APPLICATION NO.	FILING DATE	FIRST NAMED INVENTOR	ATTORNEY DOCKET NO.	CONFIRMATION NO.
10/690,062	10/21/2003	Miguel A. Frontera Castaner	P2039US	3486

Office Action Summary

FRONTERA CASTANER, MIGUEL
A.

**Fig.3.**

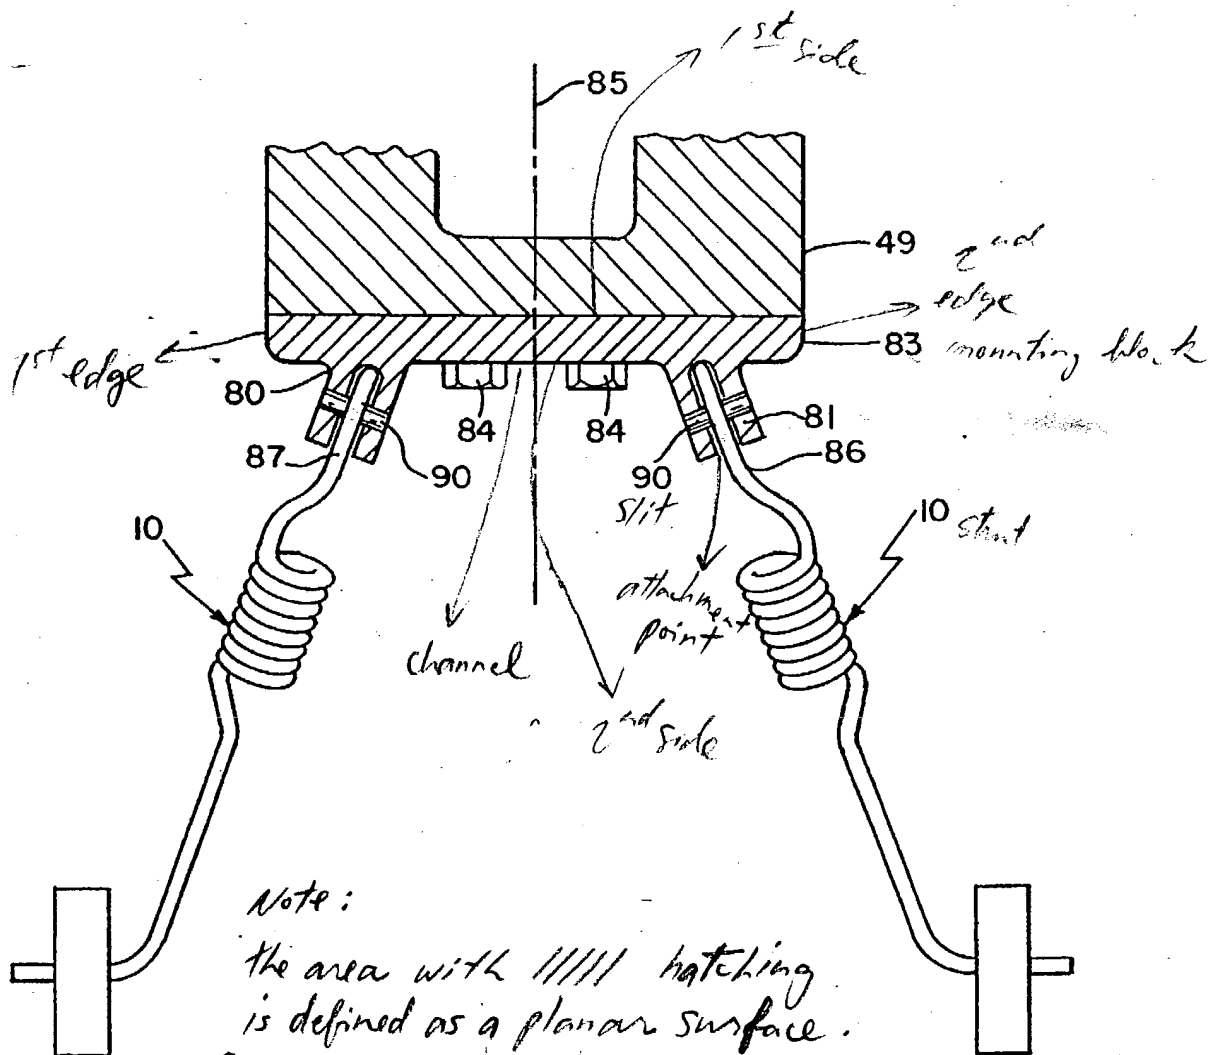
3. Claims 1-3, and 14-16 are rejected under 35 U.S.C. 102(b) as being anticipated by Cohen (US 5,575,700) (Please see a more detail Figure 3 attached with the Office Action for further explanation).

For claims 1 and 14, Cohen teaches a model aircraft having a landing gear assembly comprised of: a mounting block (83); and a pair of landing gear struts (10) attached to the mounting block.

For claims 2 and 15, Cohen further teaches the mounting block includes an individual attachment point for each landing gear strut comprising the pair of landing gear struts.

For claims 3 and 16, Cohen further teaches the mounting block has a planar surface having a first side and a second side, and the second side of the planar surface defines a channel with respect to a first and a second edge of the mounting block; the planar surface defines a pair of slits; and at least one of the pair of slits surrounds a portion of an individual attachment point.
